Standards Update Transmittal

Reference Number: 2024-13

Standards: Standard Drawings: SD-6.0, SD-6.1, SD-6.2, SD-6.3, ST-1A, ST-5, ST-8

DRAWING NUMBER
SD - 6.0

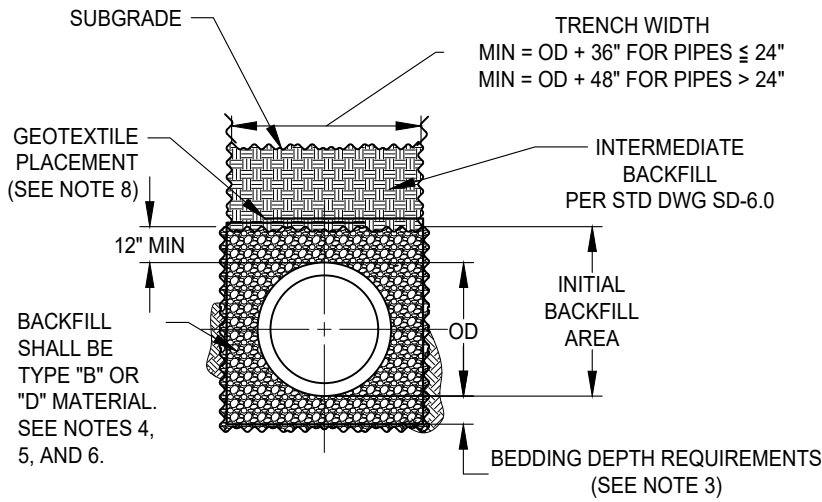
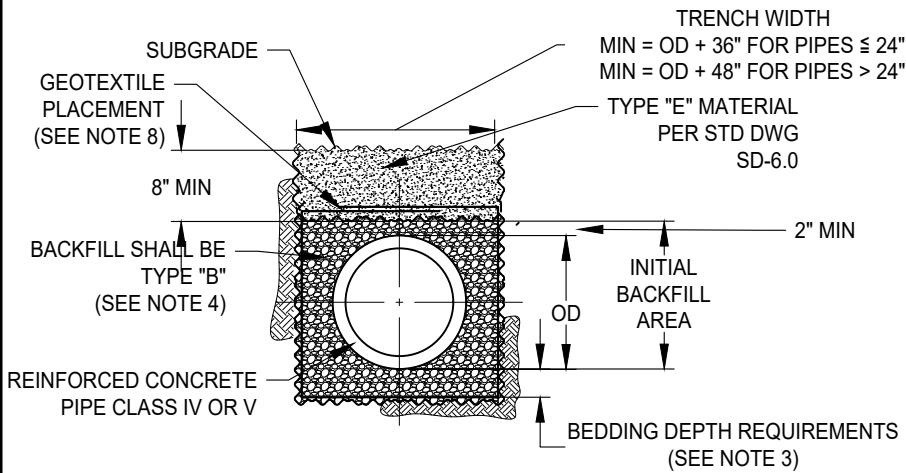
1. Modification to Standard Drawings:
 - a. SD-6.0, STORM DRAIN TRENCH DETAIL, update detail callouts and notes in “NOTES” section, show Geotextile location to match specification requirements, and removed compaction requirement to avoid confusion with the specifications.

1. These modifications are as follows:
 - a. Improve the detailed information for clarity and remove conflict with specifications.
 - b. Details are now only for RCP, improved callouts.
 - c. Details are new and is for plastic pipe.
 - d. Clarify bedding dimension to avoid confusion during contract administration.
 - e. Removed compaction conflict with the specification, and improved callouts,
 - f. Remove compaction conflict with the specifications.
 - g. Removed compaction conflict with the specification, and improved callouts.

DRAWING NUMBER
SD - 6.1

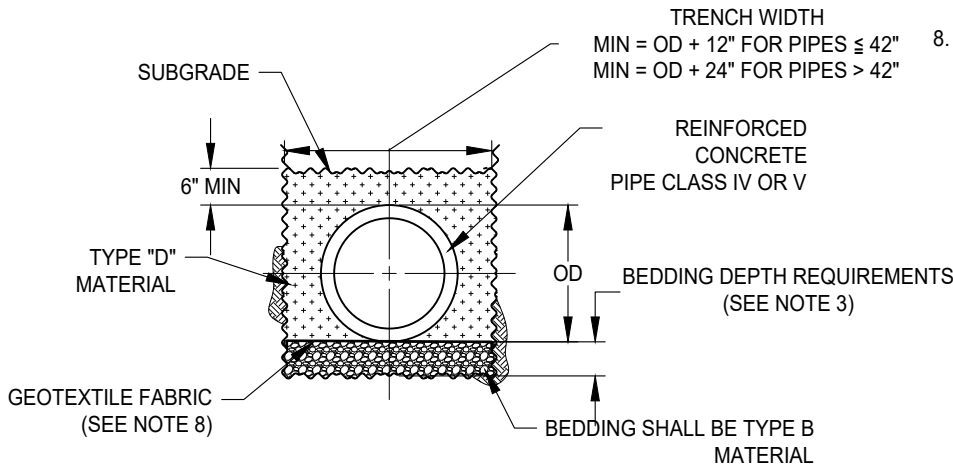
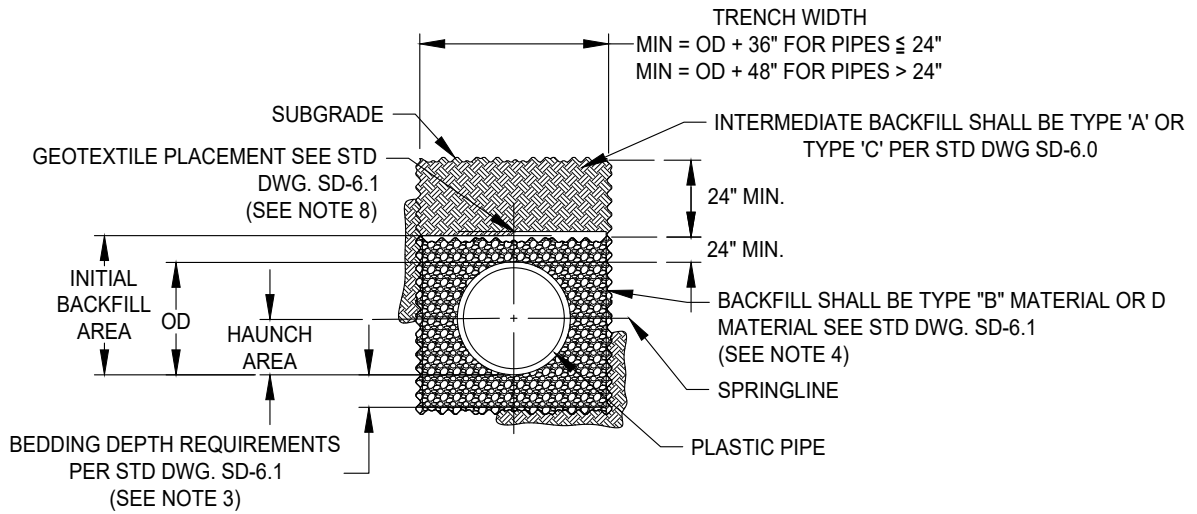
- b. SD-6.1, STORM DRAIN REINFORCED CONCRETE PIPE BEDDING AND INITIAL BACKFILL this is now a standalone detail for RCP and removed reference to plastic pipe. Updated detail callouts and General Notes, added Geotextile location to match specification requirements, added bedding to option 2, and changed trench width.

DRAWING NUMBER
SD - 6.2

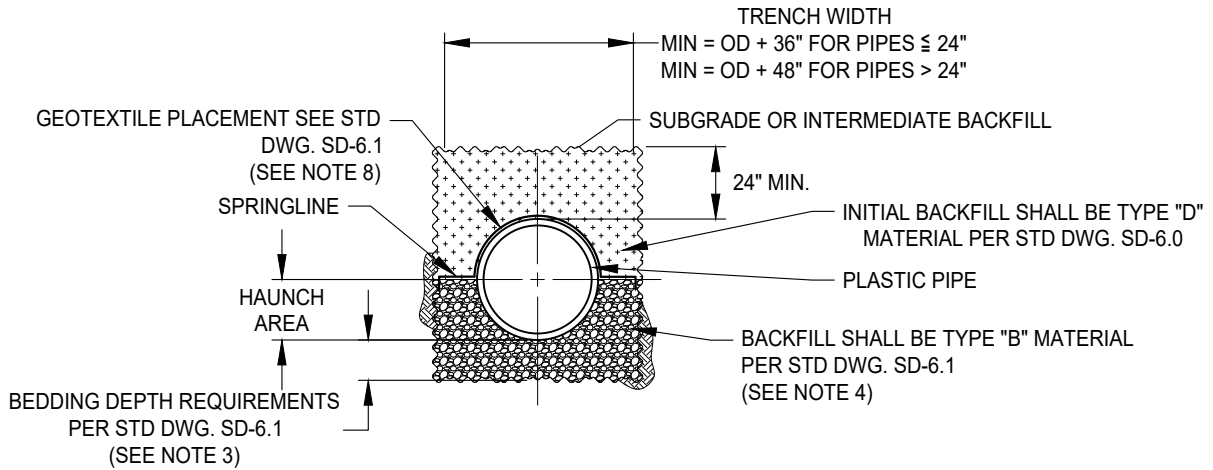
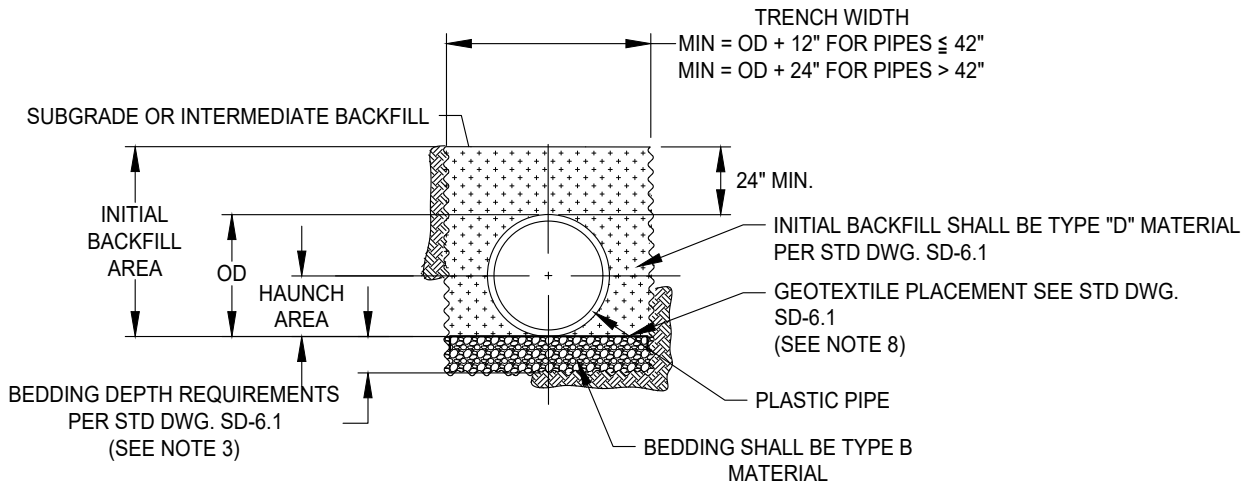
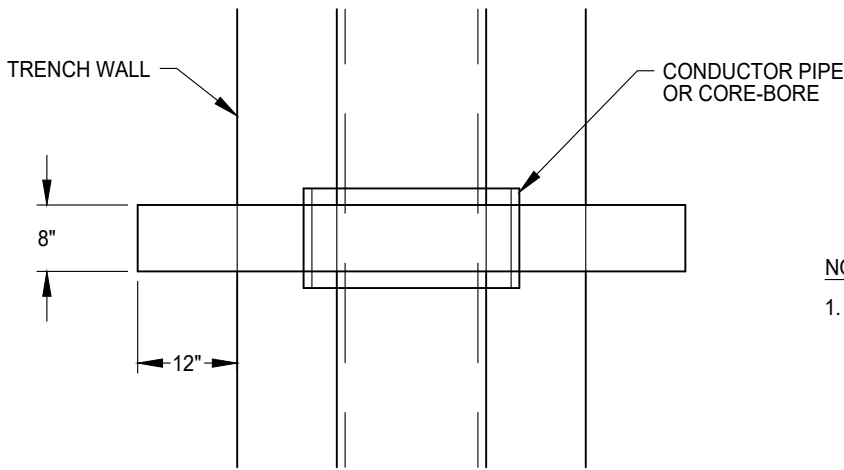
- c. SD-6.2, STORM DRAIN PLASTIC PIPE BEDDING AND INITIAL BACKFILL this is a new detail for plastic pipe. The detail has a standard detail for pipe 12-inches to less than 48-inches. Trench width based on pipe size and type of backfill. Added Geotextile location to match the specification requirements.

SD - 6.3

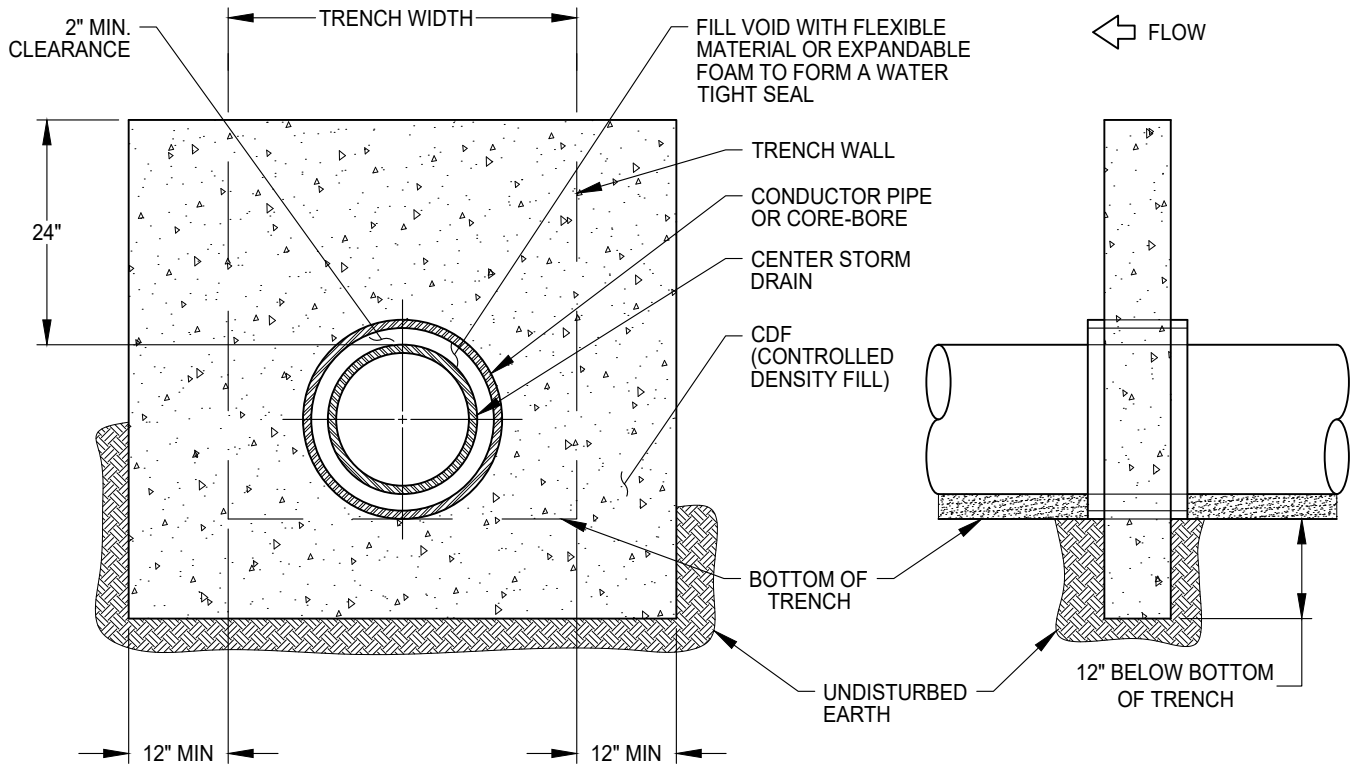
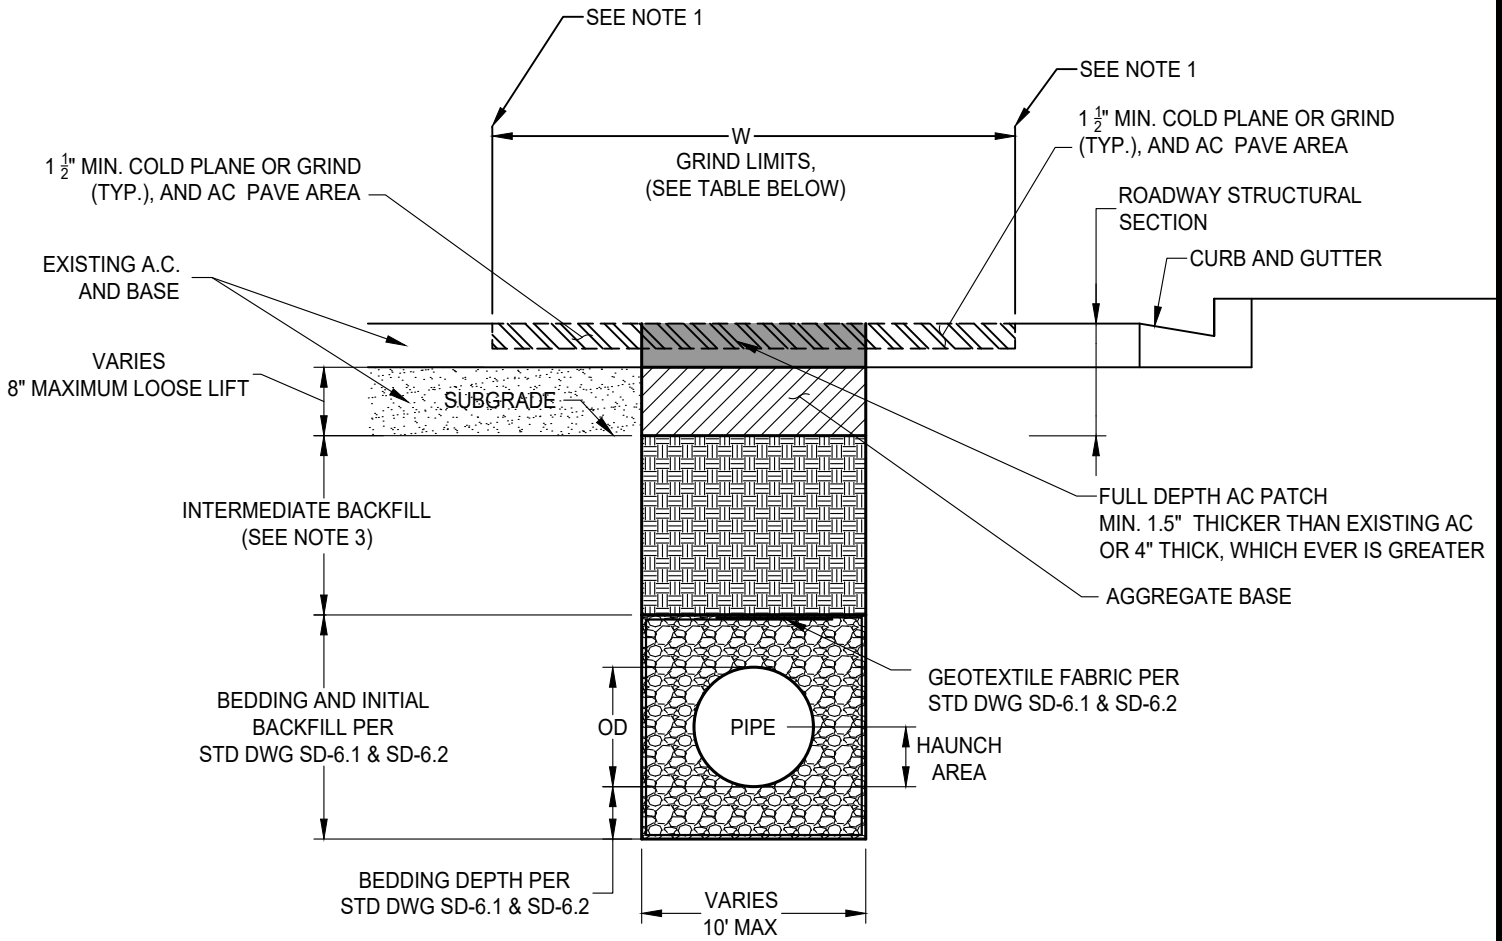
- d. SD-6.3, CUTOFF COLLAR, clarified bottom of trench dimension.
 - e. ST-1A, TRENCH BACKFILLING AND RESURFACING, removed compaction requirement to avoid confusion with the specifications, and updated detail callouts.

DRAWING NUMBER
ST - 8

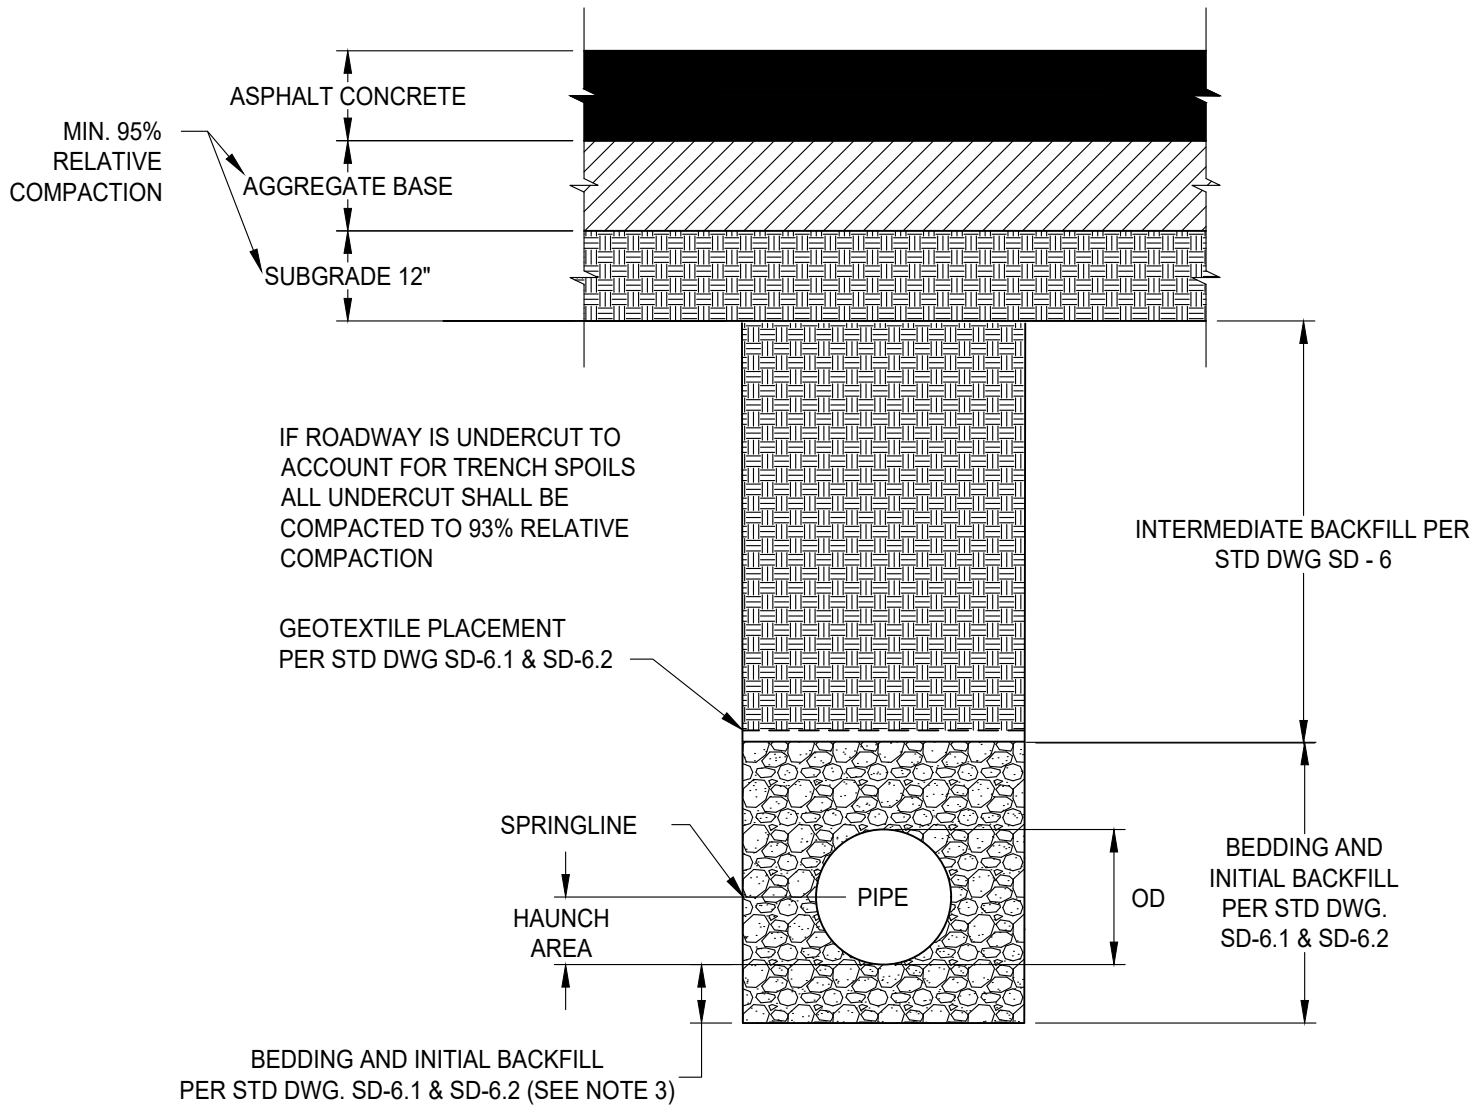
- f. ST-5, TRENCH RESURFACING WHEN FABRIC IS REQUIRED, remove compaction requirement in note 1 to avoid confusion with the specifications.
 - g. ST-8, TYPICAL TRENCH COMPACTION DETAIL, cleaned up graphics to match other detail graphics, updated detail callouts and removed compaction requirement to avoid confusion with the specifications.
